Turkey Point Units 3 and 4
Docket Nos. 50-250 and 50-251
Renewed Facility Operating License Nos. DPR-31 and DPR-41

Subject: Response to Request for Additional Information Regarding License Amendment
Request No. 231, Application to Revise Technical Specifications to Revise Ultimate
Heat Sink Temperature Limit

NRC RAI 4

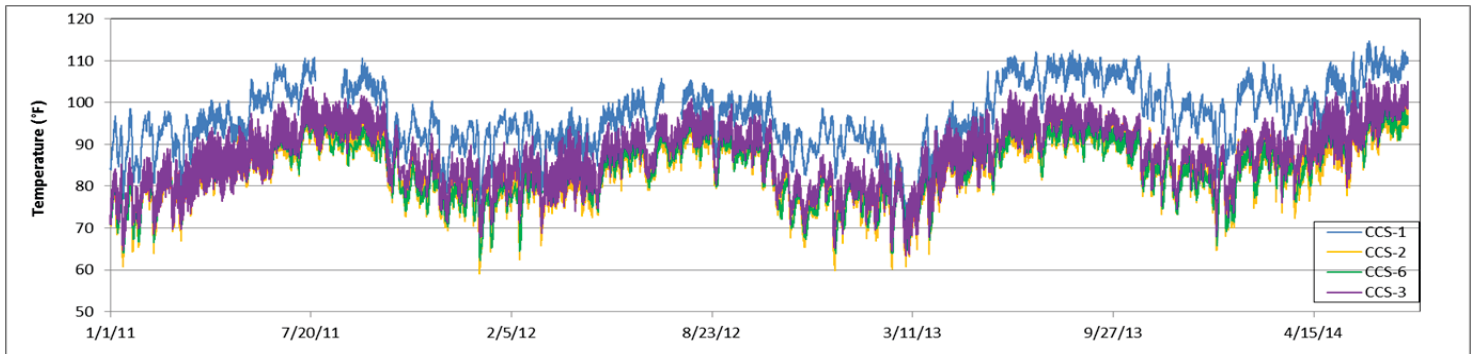
Provide an analysis of the impacts to crocodiles that would result from the temperature increase that addresses effects to crocodile growth, survival, abundance, and spatial distribution on the Turkey Point site. The analysis should also address any adverse modifications to designated critical habitat on the site. Both the direct impact of the LAR (i.e., increased cooling canal system temperatures) and any indirect impacts (e.g., increased salinity resulting from the increased evaporation rate of higher temperature water) should be addressed.

The crocodiles utilize the CCS for courting, nesting and basking. The data in the table below indicate any increase in temperature and salinity has not had an impact to the crocodiles use of the CCS.

Year	Spotlight Surveys Observances	Number of Captures	Number of Nest/Tagged Hatchlings
2011	747	117	15/268
2012	675	93	18/229
2013	646	102	25/429
2014	223 ¹	64	25/398 ²
